Access Compliance Report Public Rights-of-Way (Curb Ramps)

Main Street: ETHEREAL_ST		Cross Street: NARROW_CANYON_RD		Location:	W
ADA ID: RPRK211027135416	Ramp Type:Type 1 - Perpendicular	Initial Pass/Fail: Pass	Overall Compliance: No	Severity Score:	17

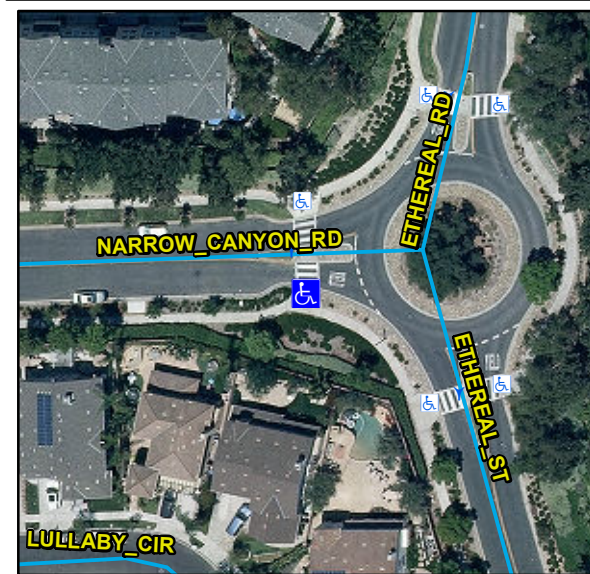
Yes	Ramp Inside Crosswalk 1	Yes	Yes	Ramp Inside Crosswalk 2	N/A
	Crossing 1 Slope (%)	1.8		Crossing 2 Slope (%)	N/A
	Crossing 1 Cross Slope (%)	1.7		Crossing 2 Cross Slope (%)	N/A
Yes	Gutter Ponding	No	Yes	Curb Slope	1.9
Yes	Gutter Lip Height (in)	0		Road Run Slope (%)	N/A
No	Gutter Run Slope (%)	8.7		Road Cross Slope (%)	N/A
Yes	Gutter Cross Slope (%)	1.9			
Yes	Overall Surface Condition: Acceptable		No	Perp Joint Present	No
	Cross Gutter Present?	No		Spandrel Present?	No
	Replace Cross Gutter?	N/A		Replace Spandrel?	N/A

Remove & Replace Entire Ramp. Remove & Replace Gutter.
